| 2 | ADDENDUM #5 | 17/03/01 | RE |

THE CITY OF WINNIPEG
PUBLIC WORKS DEPARTMENT
Waverley Street Underpass at CN Mile 3.89 Rivers Sub
Contract 2: Underpass Structure, Railworks,
Roadworks, Land Drainage Sewer, Pumping Station
and Landscaping Works
CITY DRAWING NUMBER
U-239-2016-C2-CS-041
SHEET 041 OF 085
CONSULTANT DRAWING NUMBER
C2-CS-041

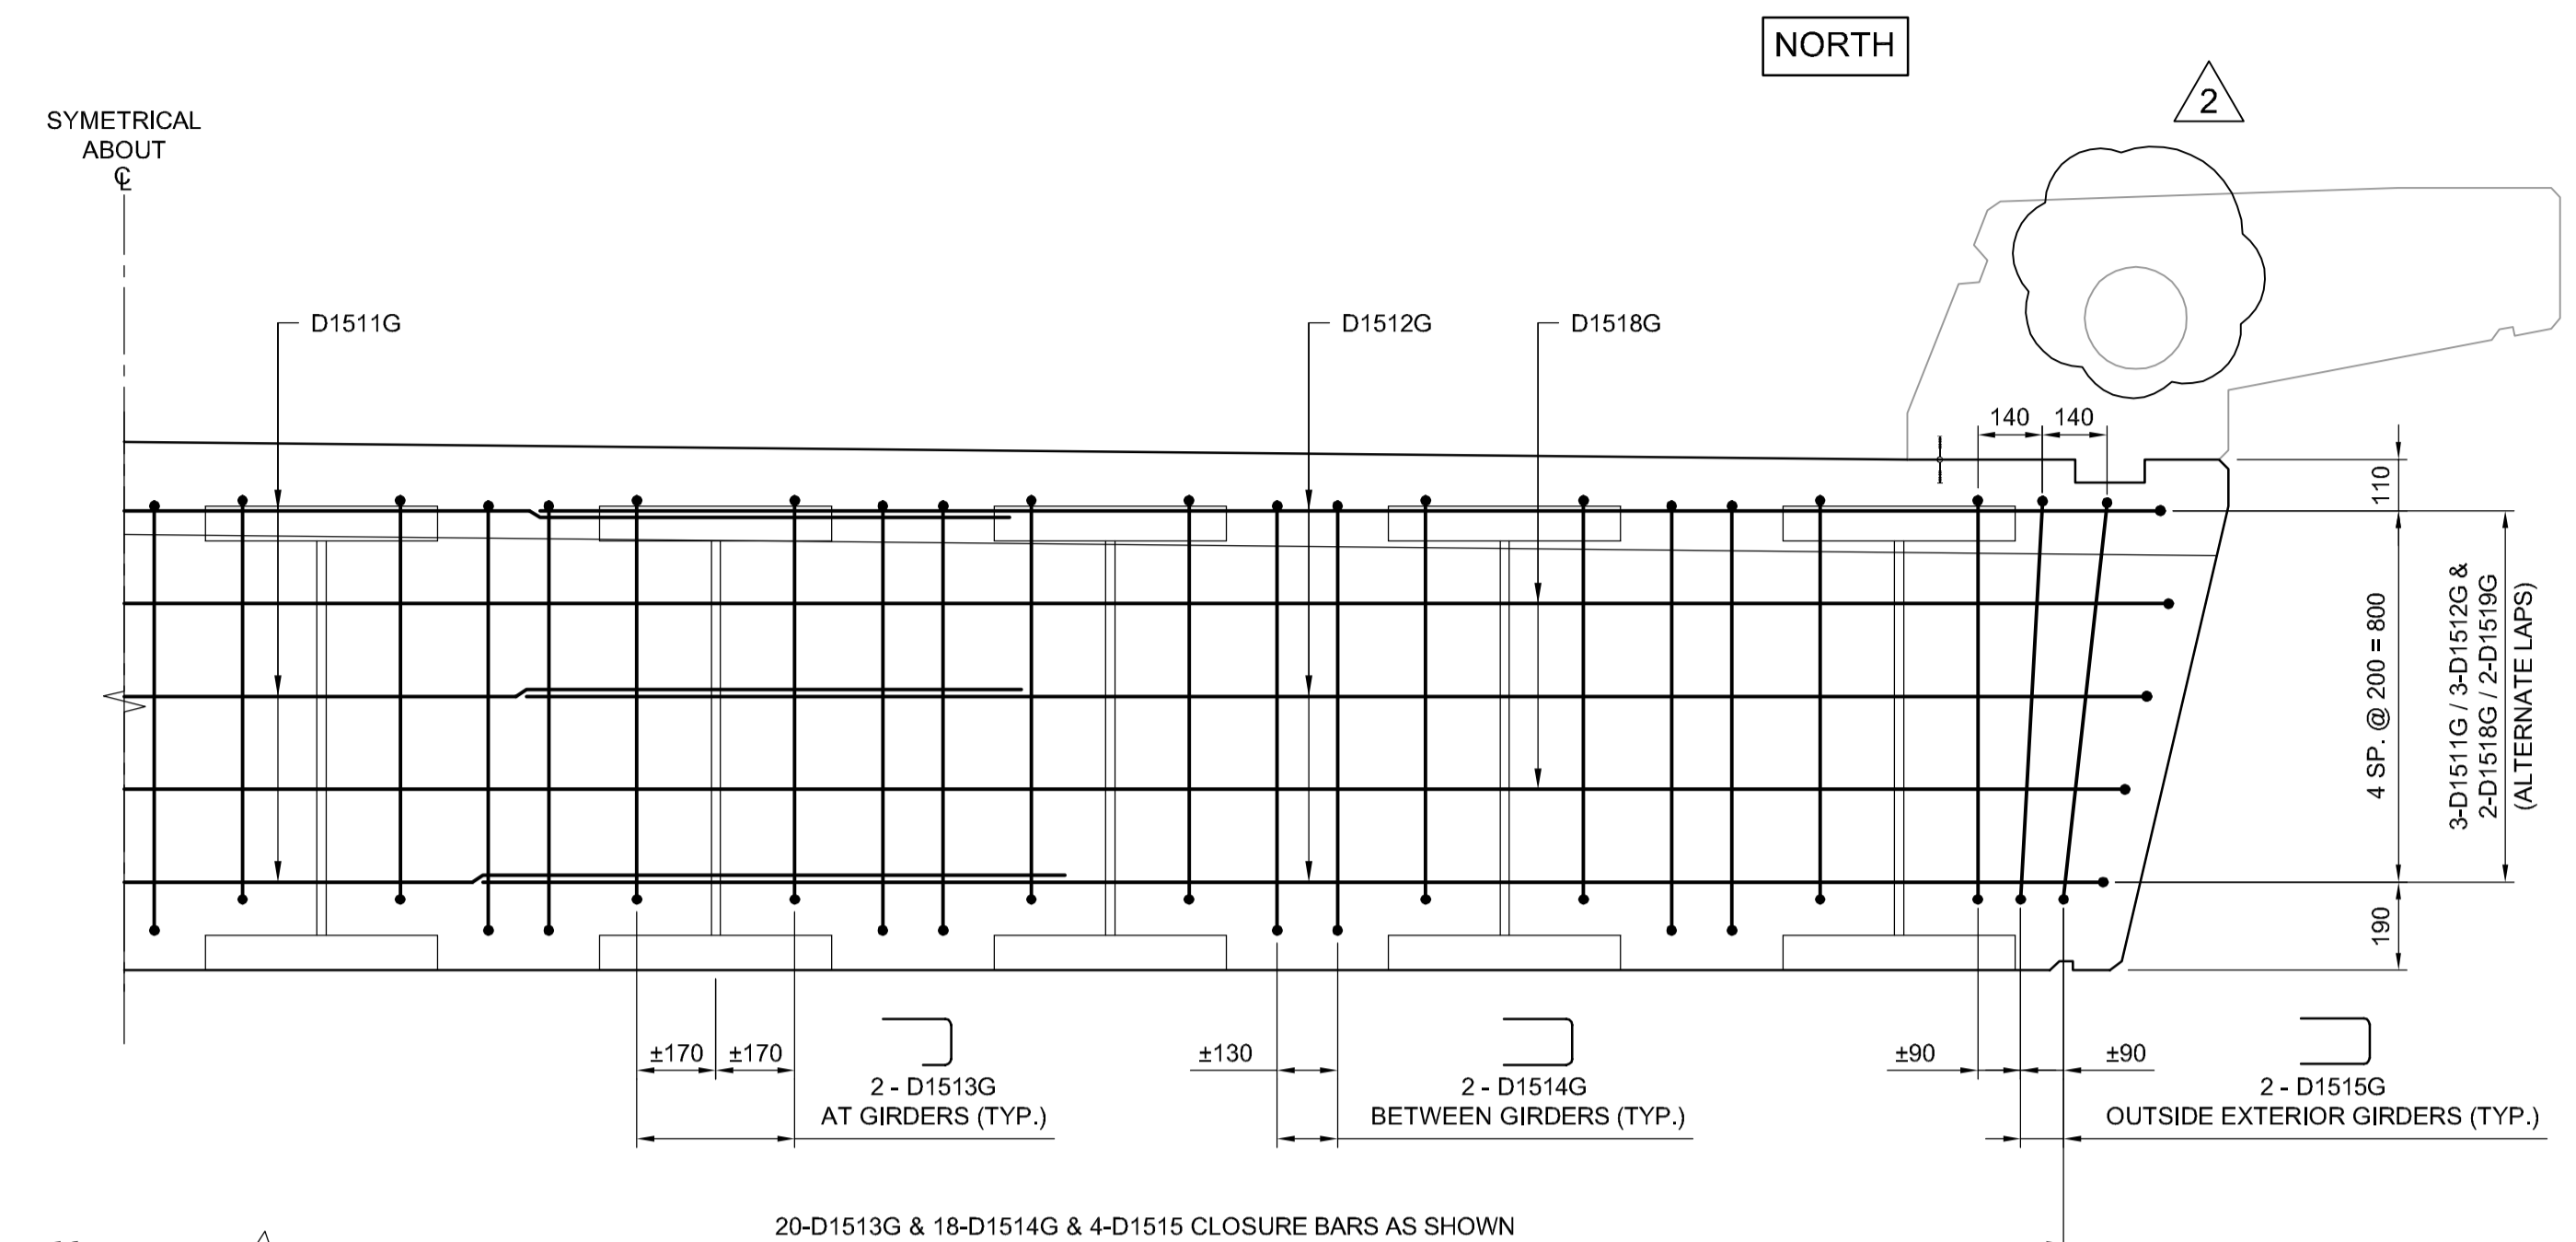
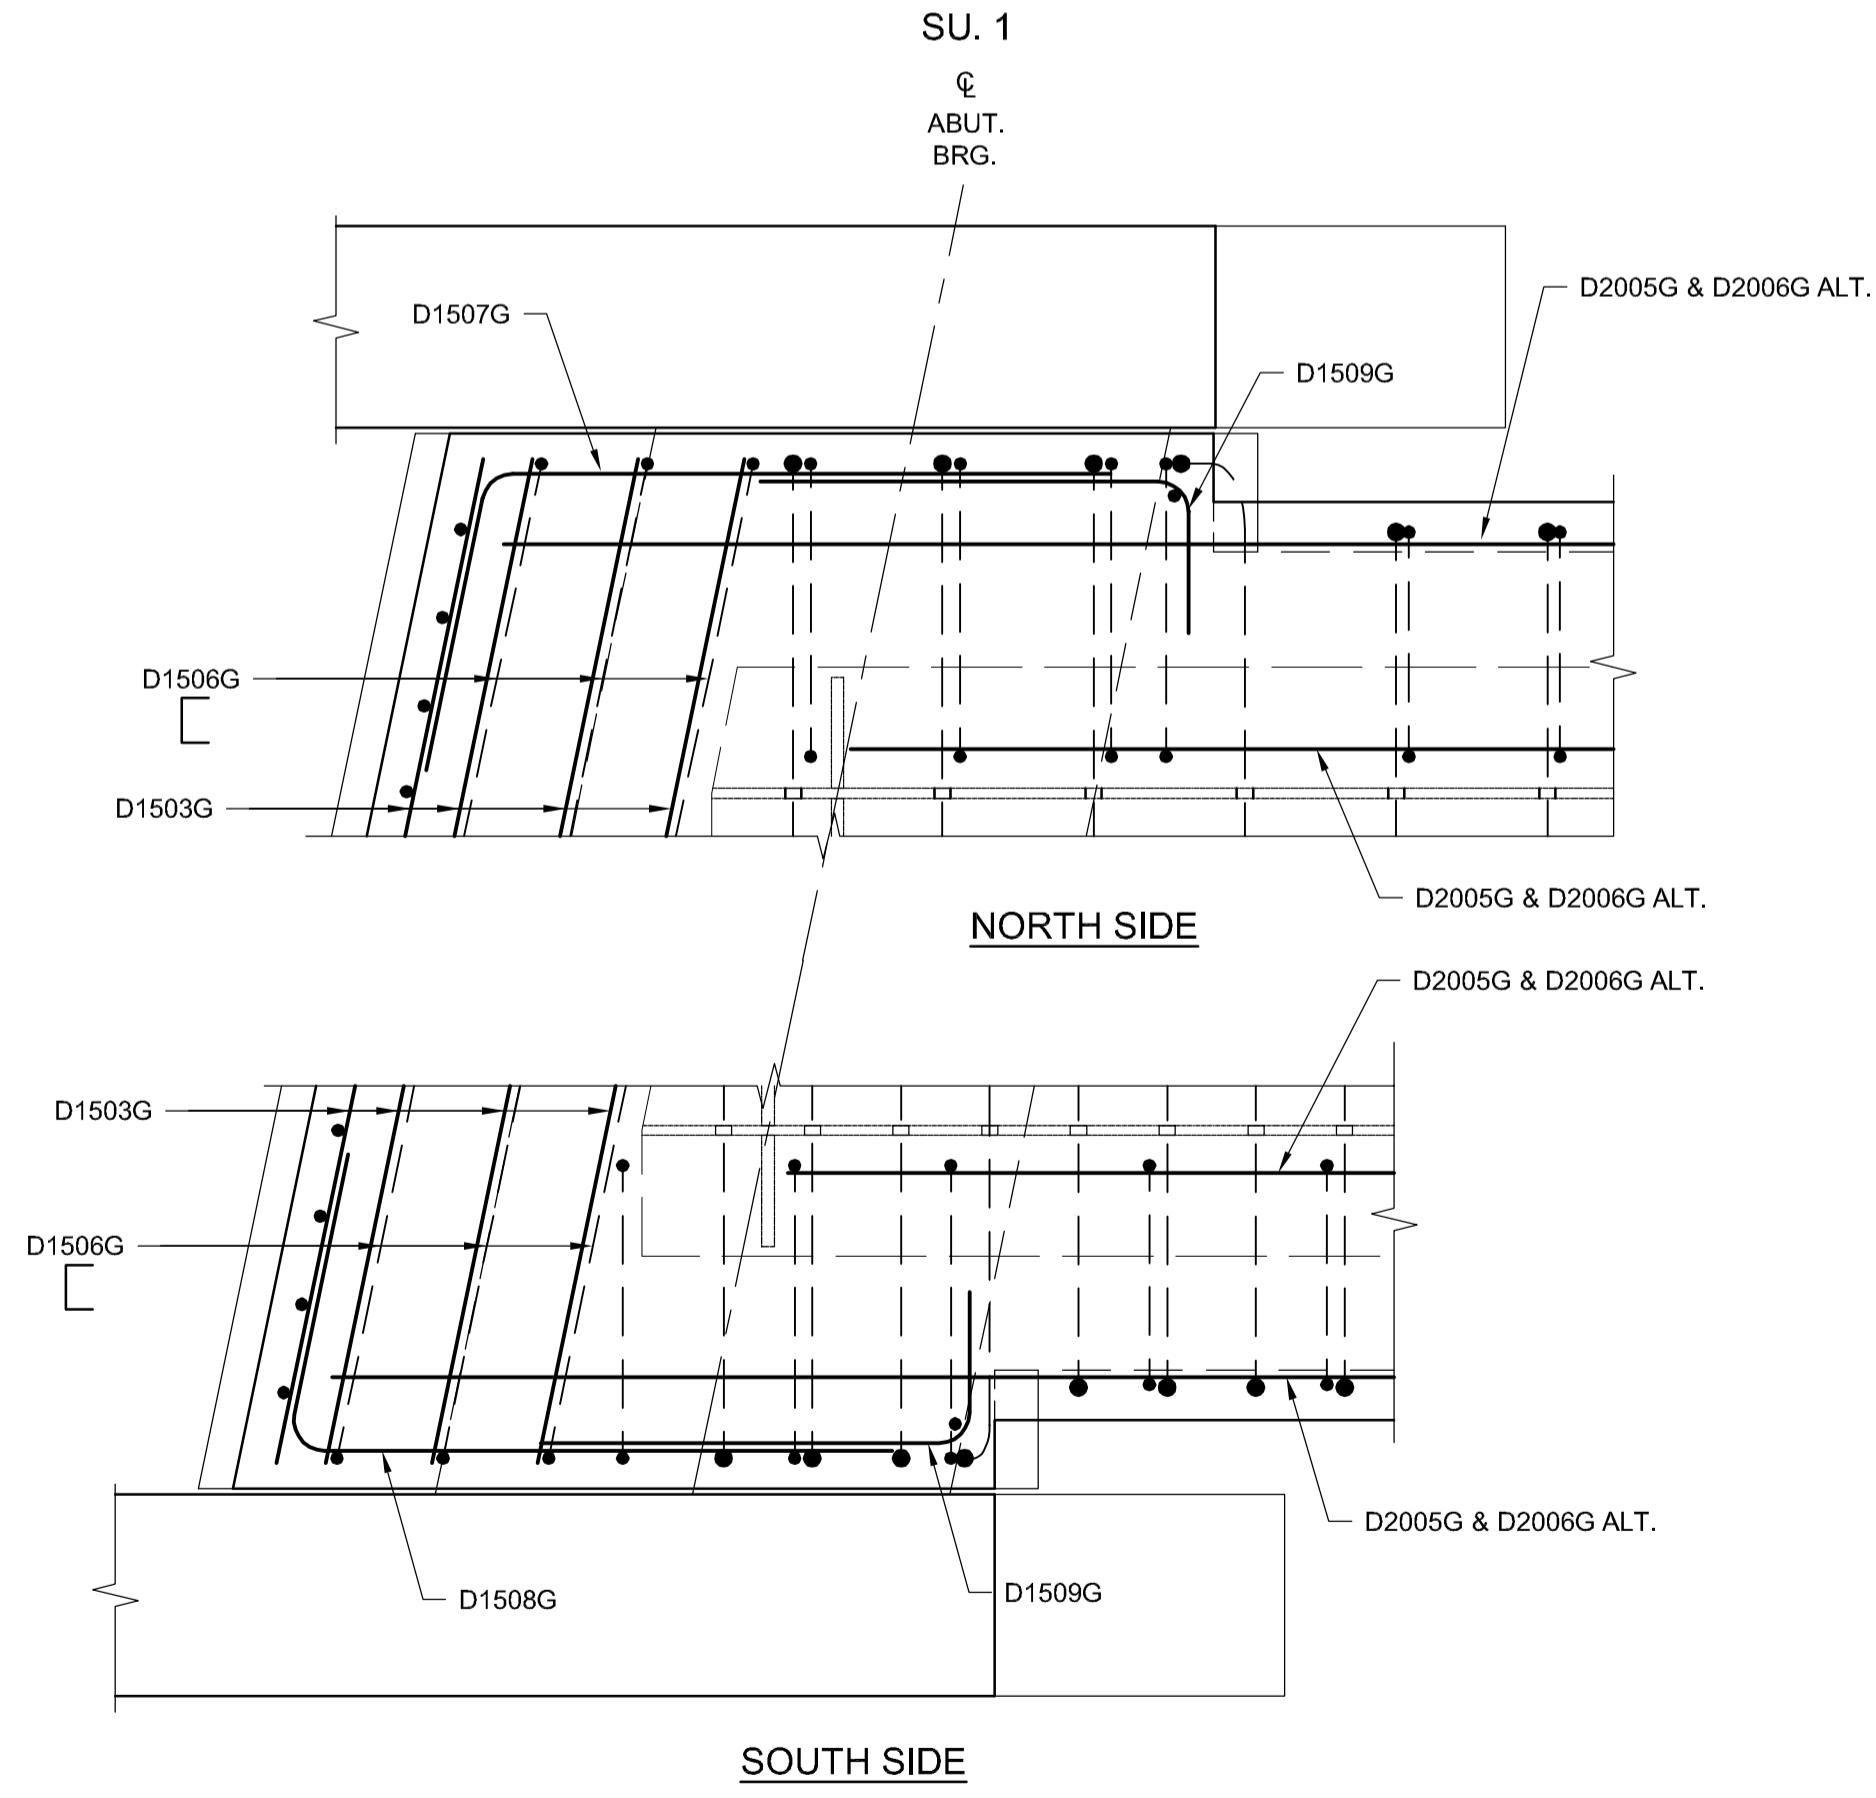
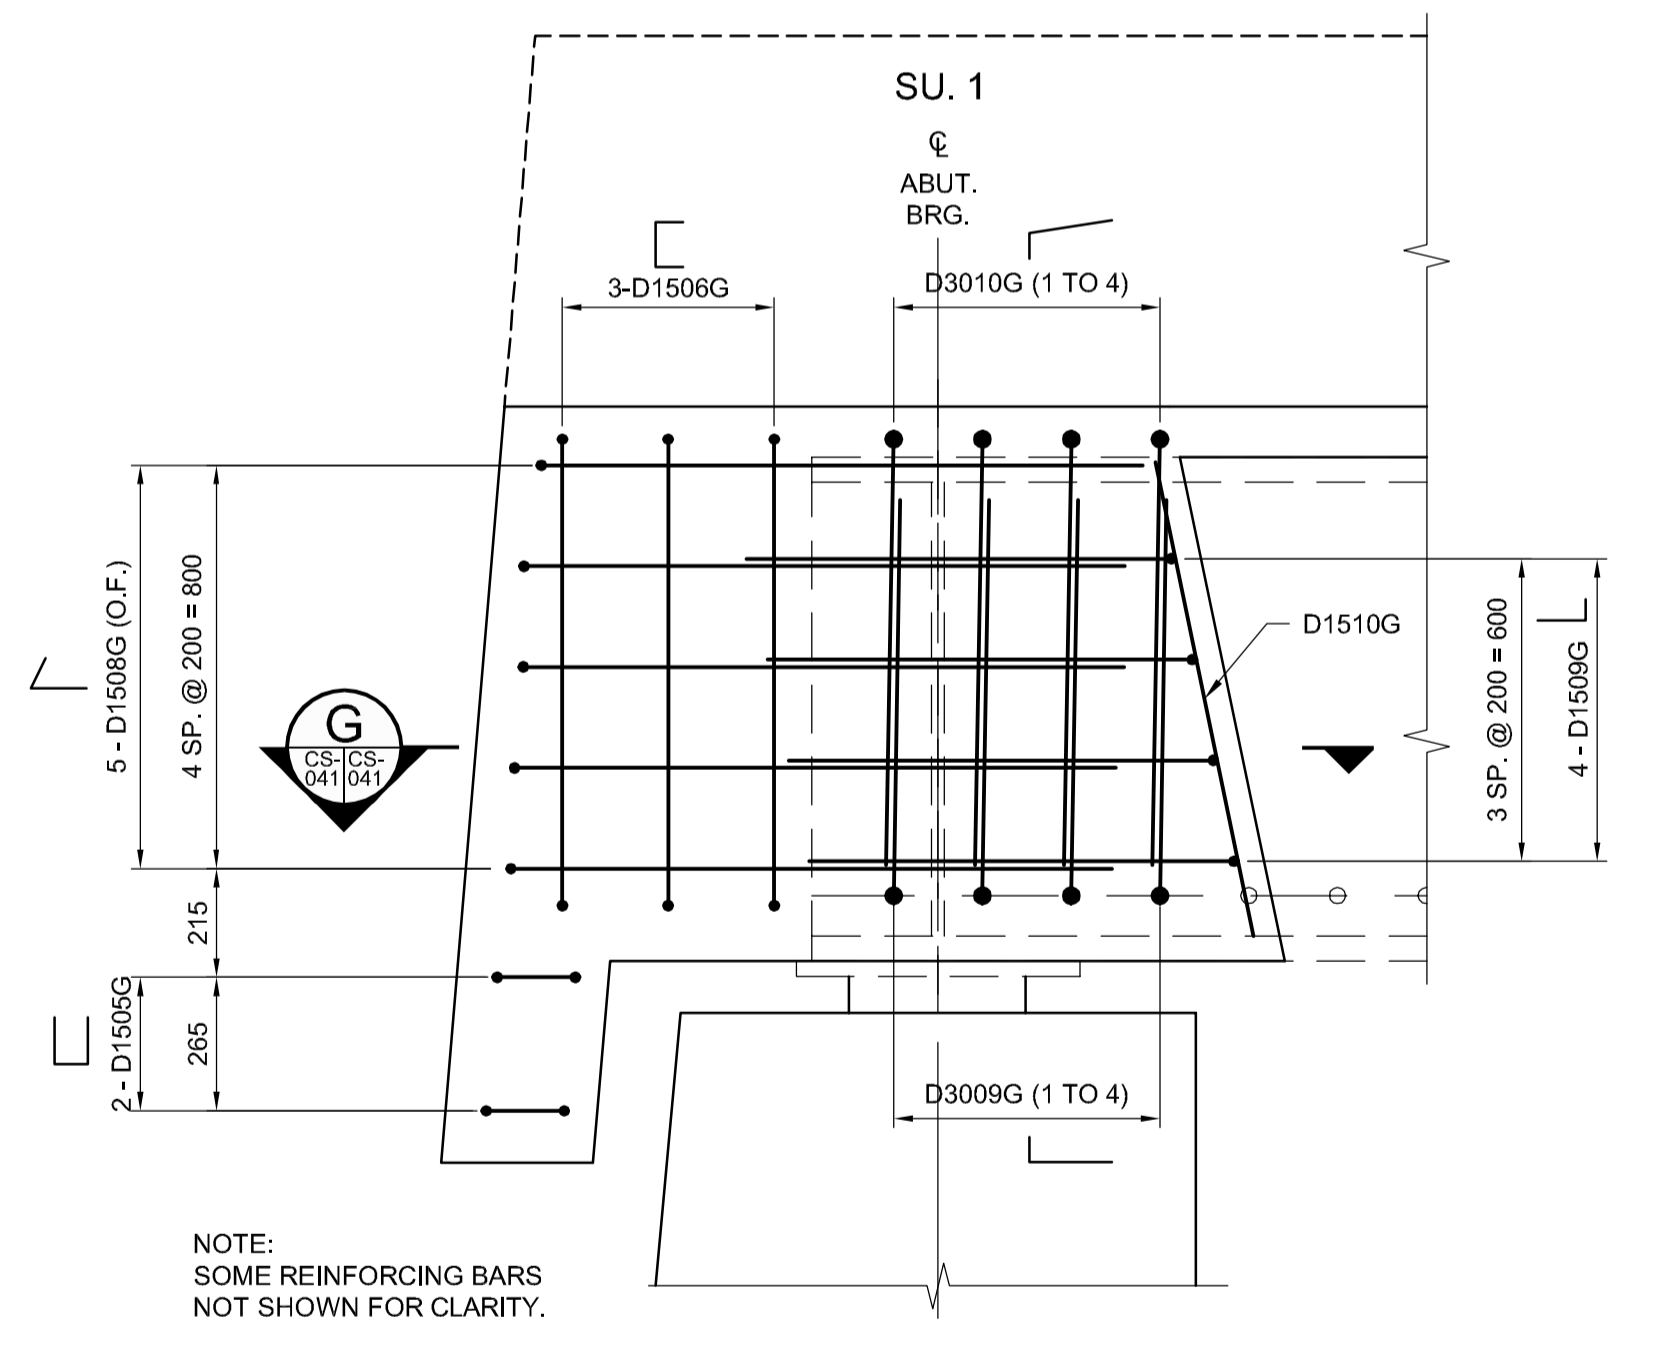
ALL REINFORCING CHANGED TO GALVANIZED REINFORCING STEEL
